1965 Corvette: Service Bulletin: Transistorized Voltage Regulator Failures

Source: Chevrolet Technical Service Bulletin

Bulletin Number: TSB #1115, Section VIy

Date: April 12, 1965

FIGURE 1 - DIODE AND WIRE ASSEMBLY (PART #2988198) INSTALLATION

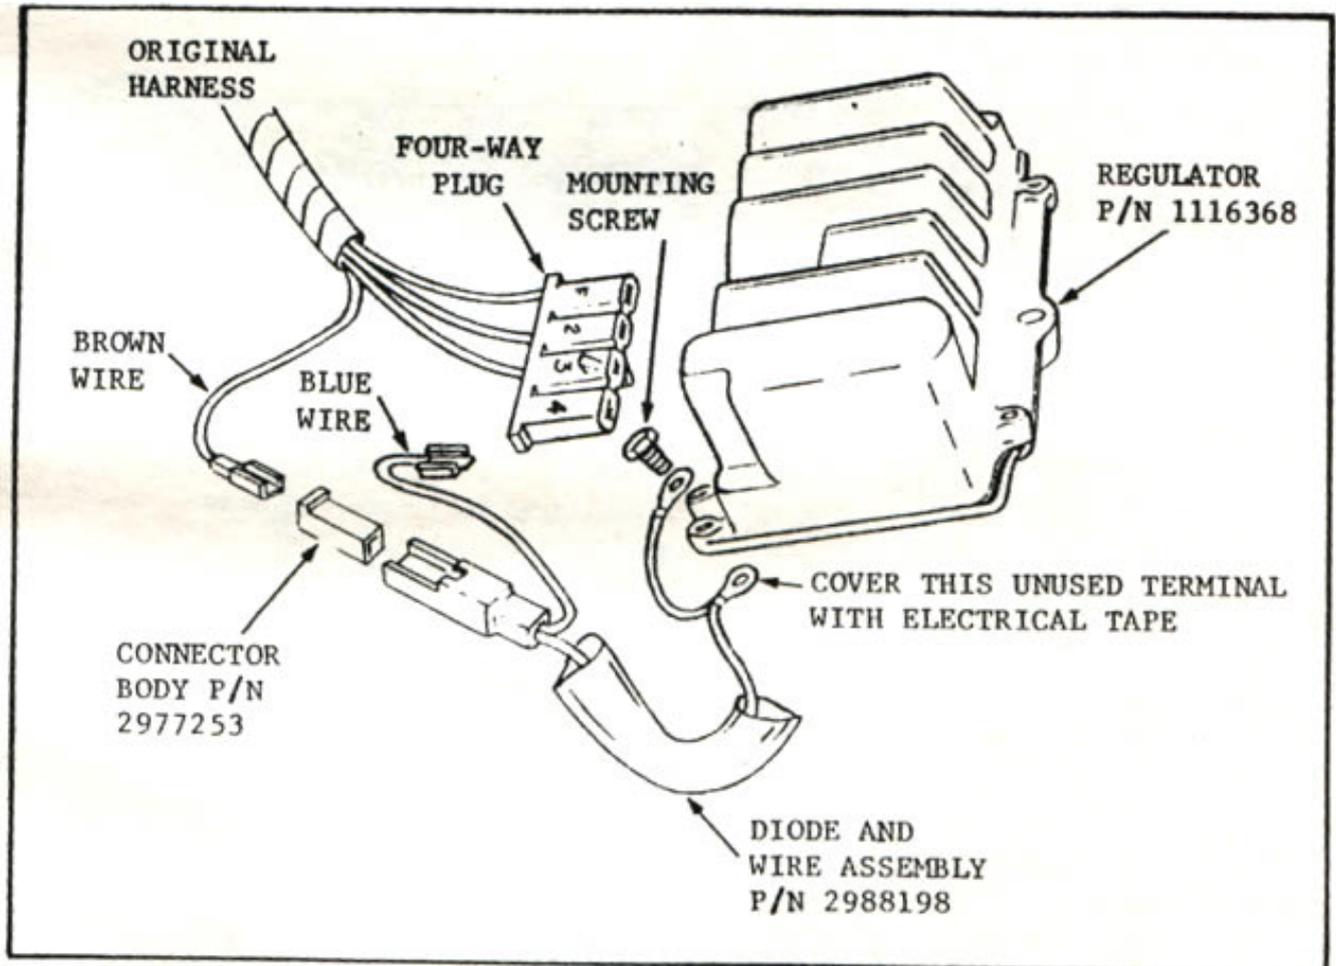
If a transistorized regulator failure is encountered on an early 1965 unit

without apparent cause, the problem may be the result of excessive reverse voltage surges generated by heater or air conditioning blower motor, power window motors, etc. when the ignition switch is moved to the "off" position. To provide a ground path for such transient voltages when installing the replacement regulator, install a suppression diode as outlined below.

1. Disconnect battery ground cable.
2. Remove four-way plug from regulator and remove regulator.
3. Remove the brown wire from the #4 location in the plug by using a small thin bladed tool to release the lock tang.
4. Obtain a Part #2988198 wire and diode assembly, and insert the spade terminal from the short blue wire into the #4 location in the regulator plug.
5. Reform the lock tang on the spade terminal of the brown wire (previously removed from the #4 position) and install a Part No. 2977253 connector body over the terminal. Plug this connector into the receptacle of the wire and diode assembly.

6. Install the regulator with the black ground "pig tail" attached by one of the mounting bolts (see fig. 1).
7. Cover the unused ground terminal of the diode lead (double black wires) with electrical tape.
8. Reinstall the regulator plug and the battery ground cable.
